City of Mississauga Department Comments

| Date Finalized: 2022-07-06 | File(s): A299.22 Ward: 1 |

Property Address: 2201 Sidney Dr

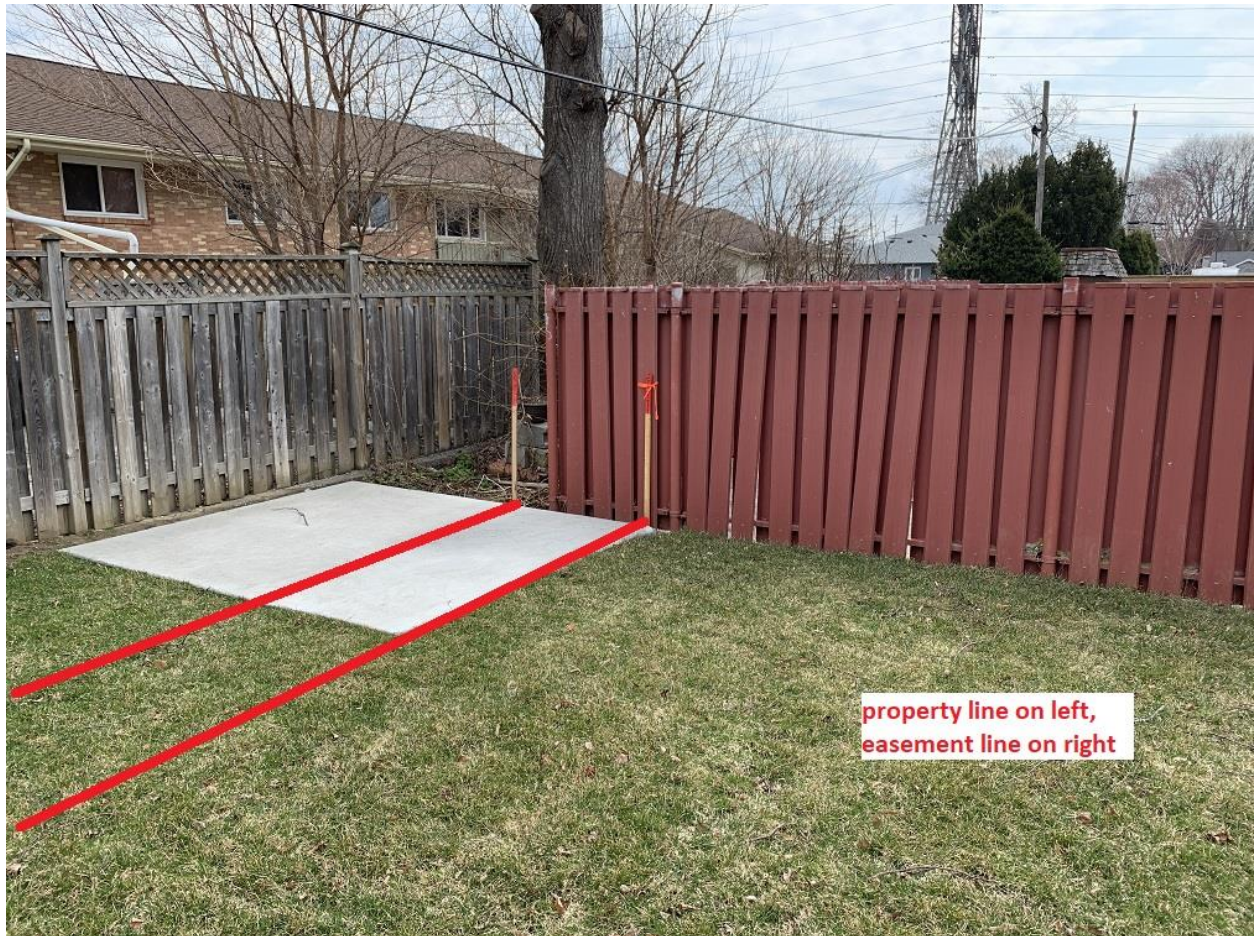
We cannot support Minor Variance number 1 that asks for a 0.25m setback to the edge of the pool. This would make maintenance for the pool problematic. We also cannot tell visibly if there is any encroachment of the underground pool equipment (piping) onto the neighbouring lands.

We cannot support Minor Variance number 2 that asks for 0.0m setback to the hard surface at the rear of the property. This would cause any splashing or flooding of the pool to flow onto the neighbouring lands to the east.

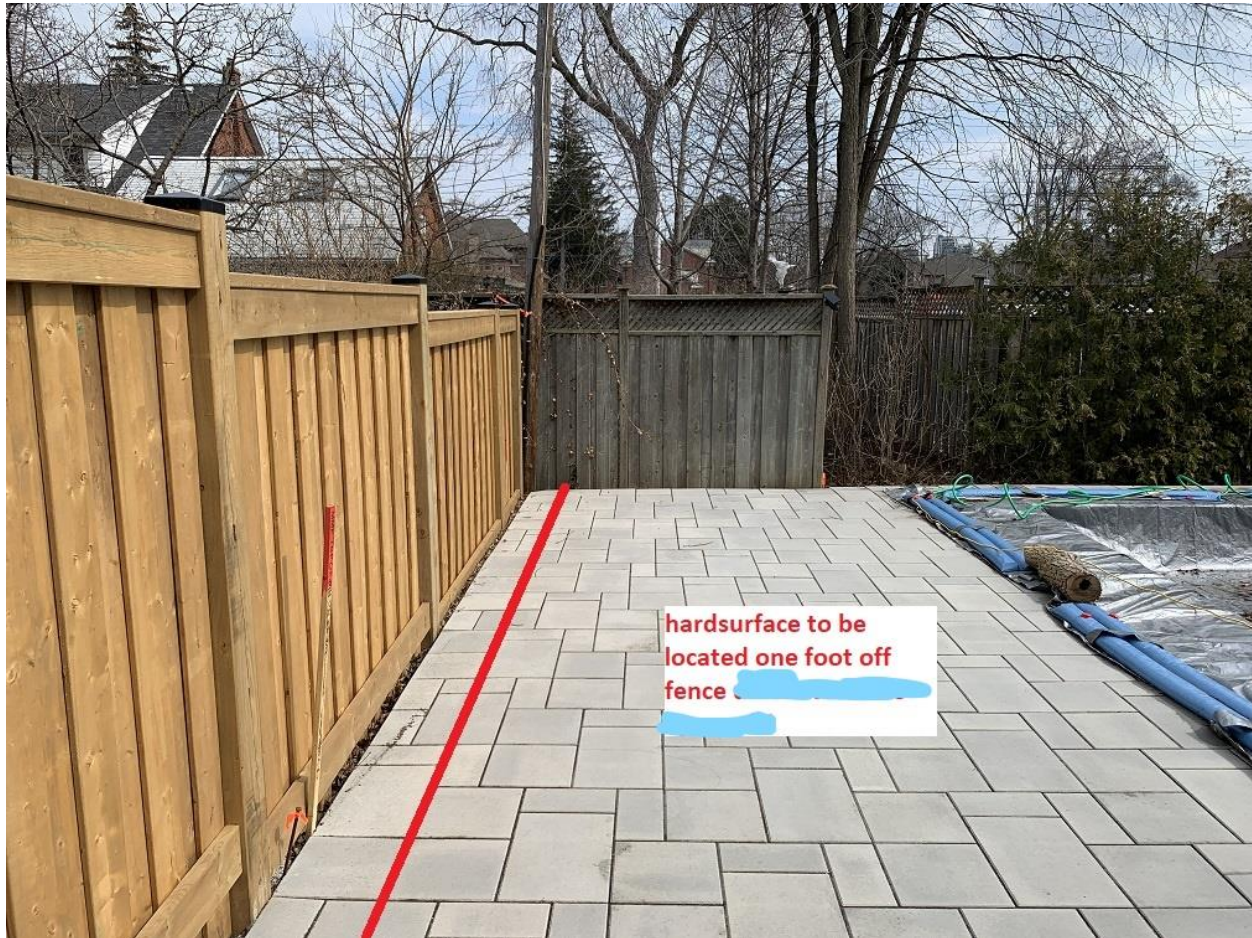
We would have no issues with Minor Variance number 3 that asks for a 0.3m setback to the hard surface along the side lot line.

We ask that the rear fence be relocated to be within the applicant's own lands. The hard surface at the north/side edge of the lot would need to be cut back at a minimum 0.3m from the side lot line to allow for surface drainage not to be directed onto the neighbouring lot. The concrete pad would need to be relocated as well.
